SUBJECT: Grand Gulf Nuclear Station
Unit 1
Docket No. 50-416
License No. NPF-29
Implementation of GL 88-06: Revision
to Technical Specifications Section 6.0
Proposed Amendment to the Operating
License (PCOL-88/06 Revised)
AECM-88/0106

A. SUBJECT

1. NLS 86/15 Implementation of Generic Letter 88-06: Revision to Technical Specifications Section 6.0.
2. Affected Technical Specifications:
 - a. Index - Page xix
 - b. Offsite, Administrative Controls Subsection 6.2.1 - Page 6-1
 - c. Unit Staff, Administrative Controls Subsection 6.2.2 - Pages 6-1 and 6-2
 - d. Offsite Organization, Figure 6.2.1-1 - Page 6-3
 - e. Unit Organization, Figure 6.2.2-1 - Page 6-4.

Insert 2

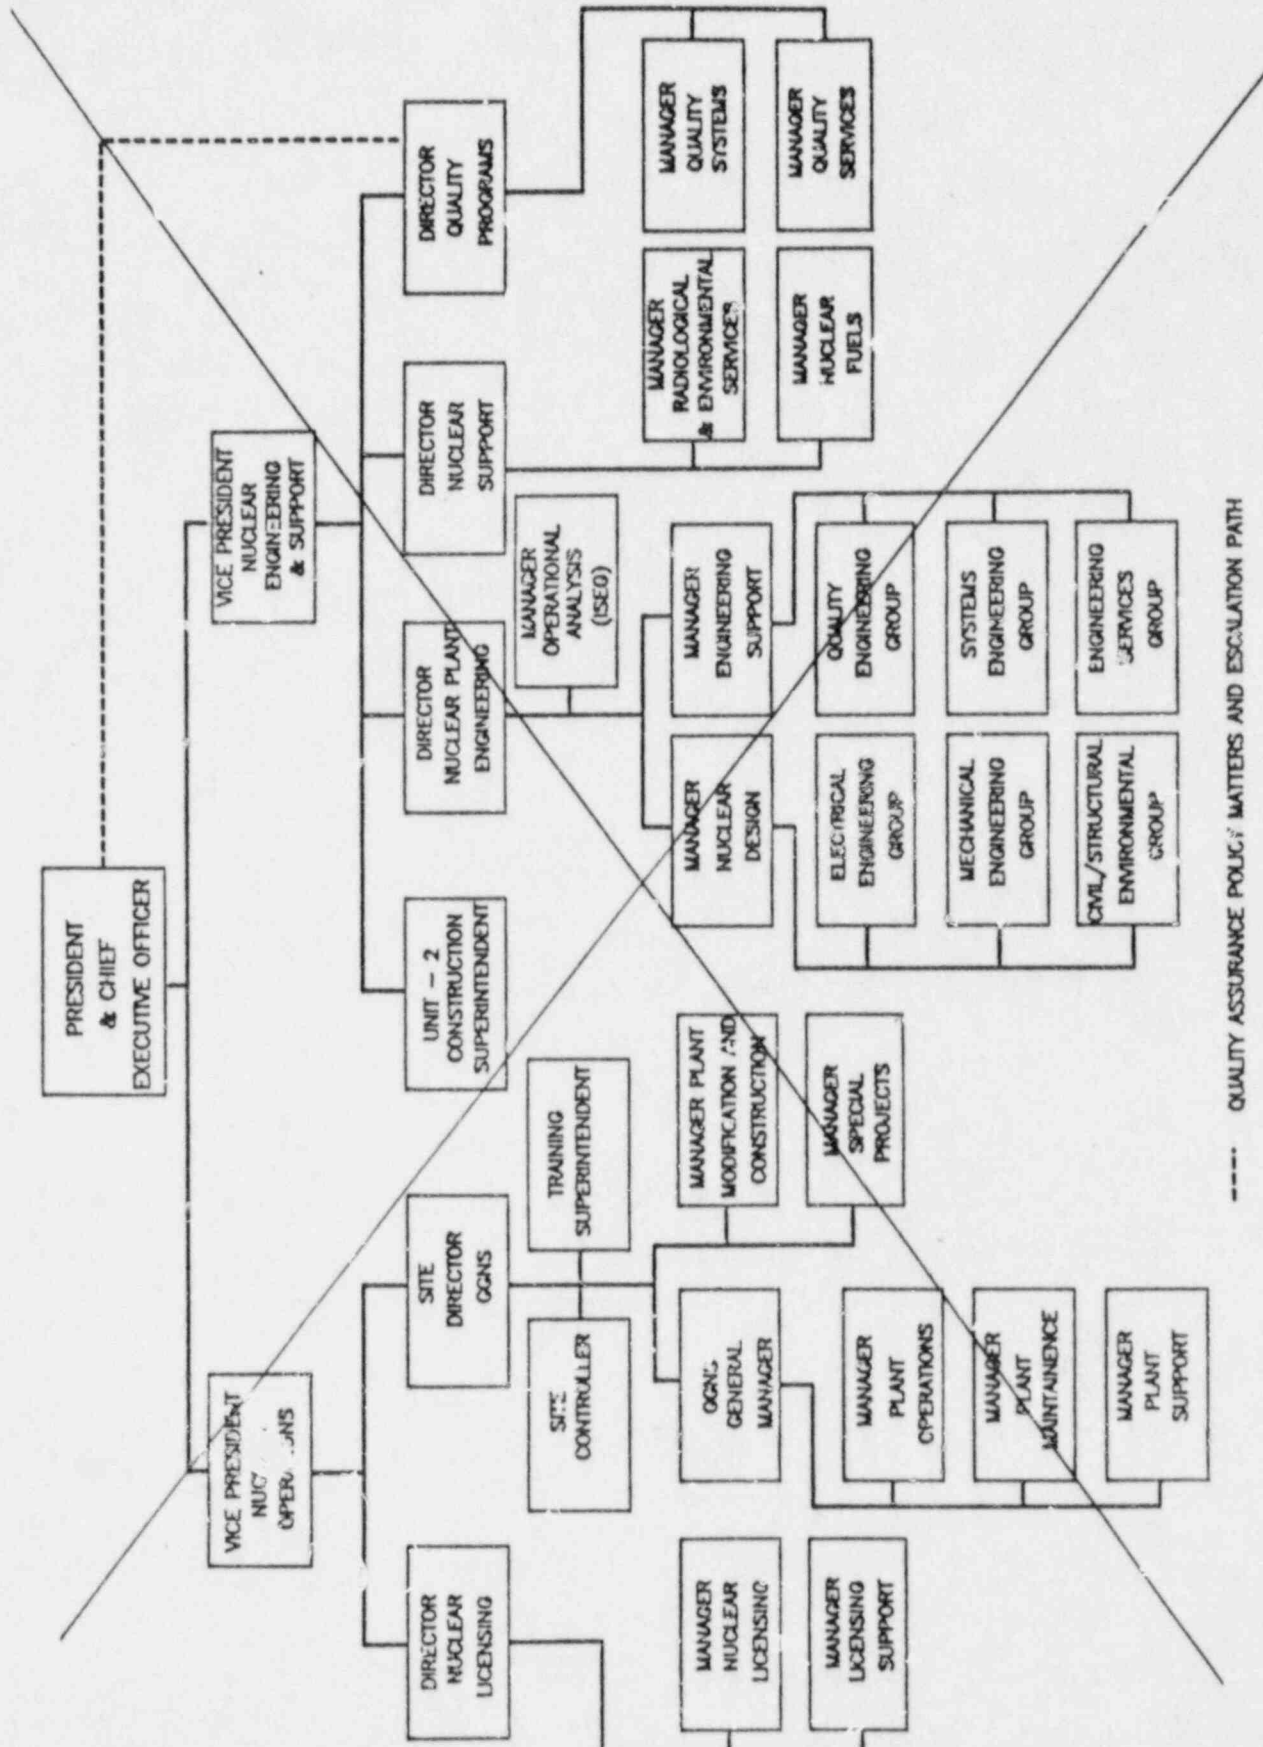
- c. The reference to Figure 6.2.2-1 is deleted in Subsection 6.2.2. In addition, a statement is added designating those positions in the onsite organization that require a Senior Reactor Operator (SRO) license.
 - d. A statement is added in Subsection 6.2.2 designating the Manager Plant Operations as must having been an SRO or having been certified on a plant of this type. R
R
R
 - e. Figure 6.2.1-1 is deleted. R
 - f. Figure 6.2.2-1 is deleted. R
4. Attached to this proposed Technical Specification change are the affected Technical Specification pages.

7. Figure 6.2.2-1 currently specifies that certain positions require an SRO license. These qualification requirements are not designated elsewhere in the Technical Specifications outside of the organization chart in Figure 6.2.2-1. For this reason, a statement is being added to Technical Specification 6.2.2 specifying the positions which require an SRO license that were designated in Figure 6.2.2-1. R

8. Figure 6.2.2-1 also currently specifies that certain positions must have been an SRO or have been certified on a plant of this type. This same information is also specified in UFSAR Chapter 13.1. Consistent with the NRC guidance provided in GL 88-06 that only those details of the organizational charts essential to safe facility operation remain in the Technical Specifications, these position qualifications will be removed from the Technical Specifications and will remain in the UFSAR. However, the requirement for the Manager Plant Operations to have been an SRO or have been certified on a plant of this type is added to Technical Specification 6.2.2. This is consistent with the intent of 10CFR50.54(1) which stipulates that those individuals responsible for directing the licensed activities of licensed operators shall themselves be licensed as an SRO. Since the Manager Plant Operations does not directly supervise licensed operators who perform licensed activities, the position does not require an SRO license, unlike the Operations Superintendent who is required to hold an SRO license because reporting to this position are licensed operators who perform licensed activities. However, SERI considers it prudent to retain the Manager Plant Operations qualification requirement in the Technical Specifications because of this position's influence upon safe plant operations. R

- g. The Operations Superintendent, Shift Superintendents, Operations Assistants, and Shift Supervisors shall each hold a Senior Reactor Operator License.
- h. The Manager Plant Operations must have been a Senior Reactor Operator or have been certified on a plant of this type. R
R

FIGURE 6-2.2-1 UNIT ORGANIZATION
DELETE

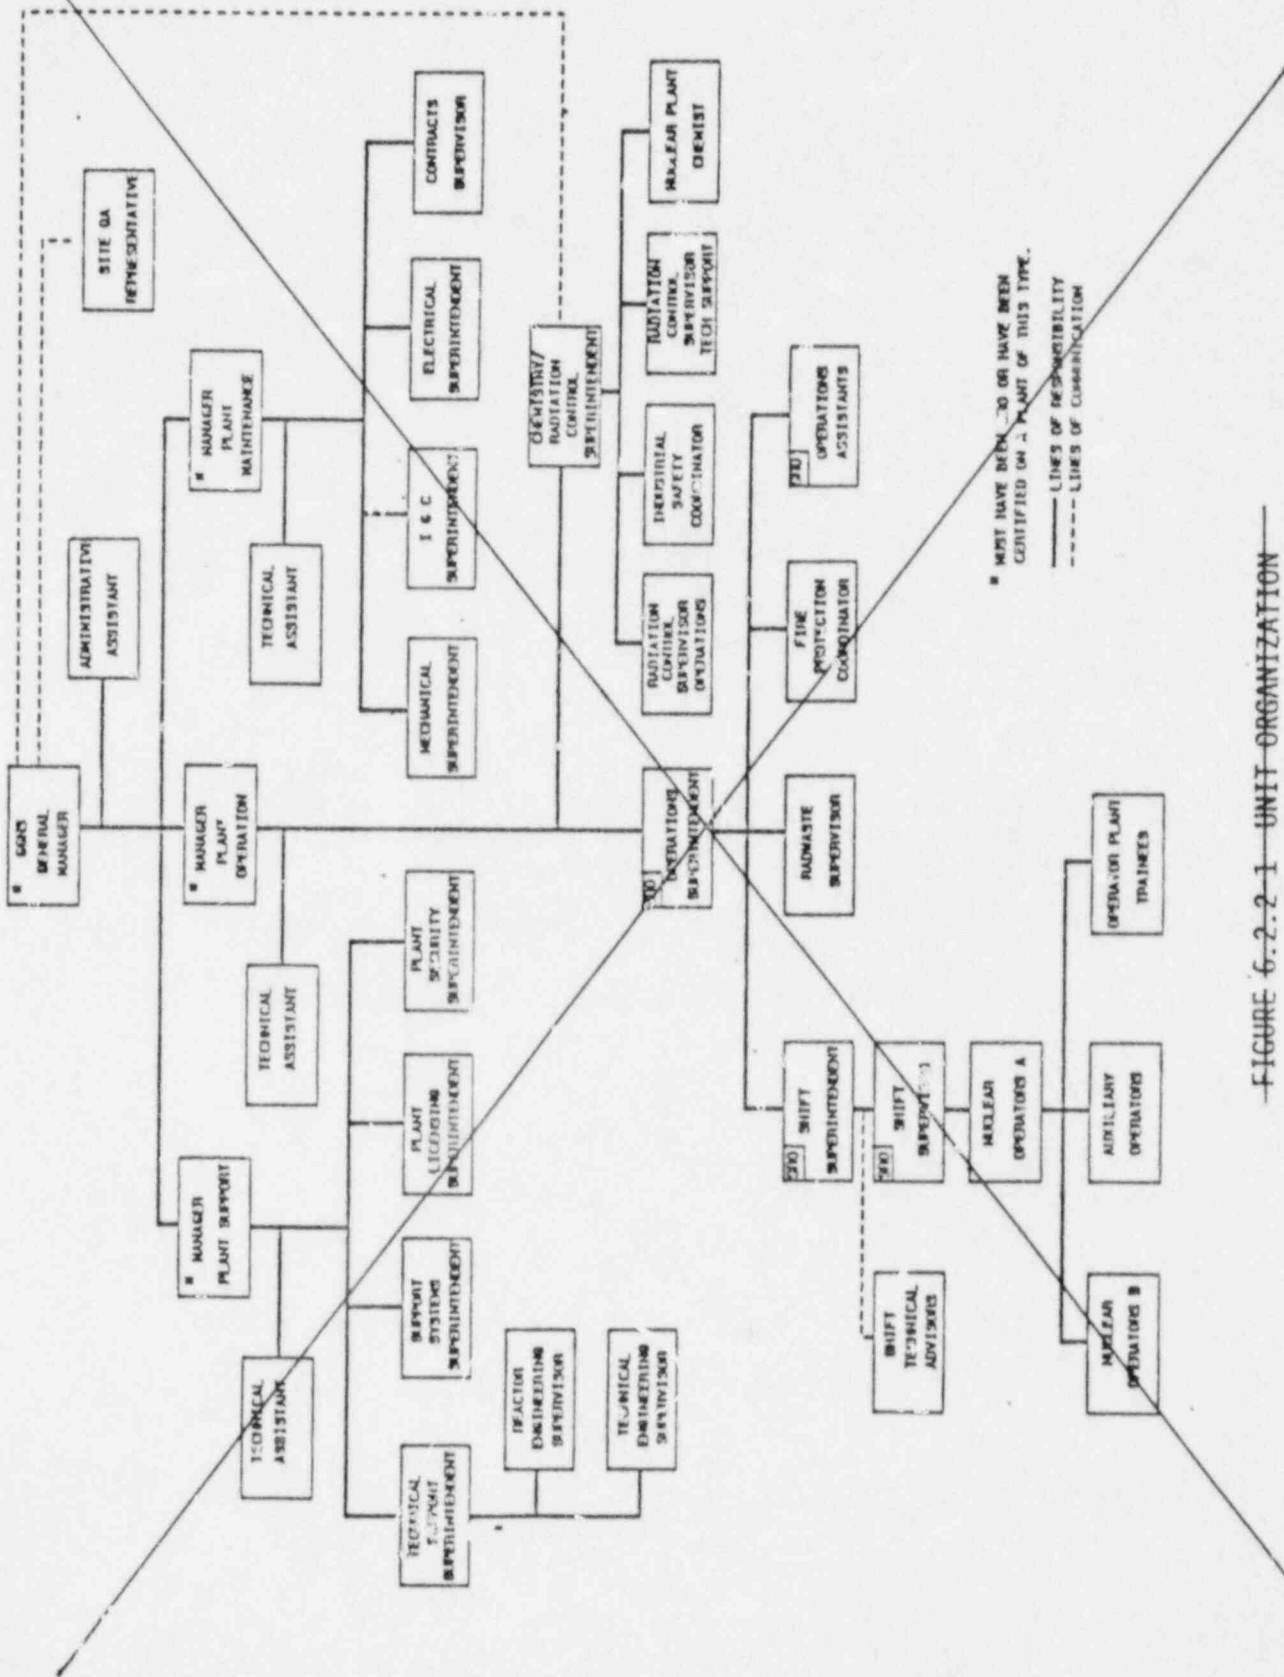
10. Table 6.2.2-1 will remain to indicate the minimum shift crew composition and the number of personnel required to have an RO license on shift. R
R
R
11. Therefore, no position qualifications important to safety will be lost when Figure 6.2.2-1 is deleted. R
R
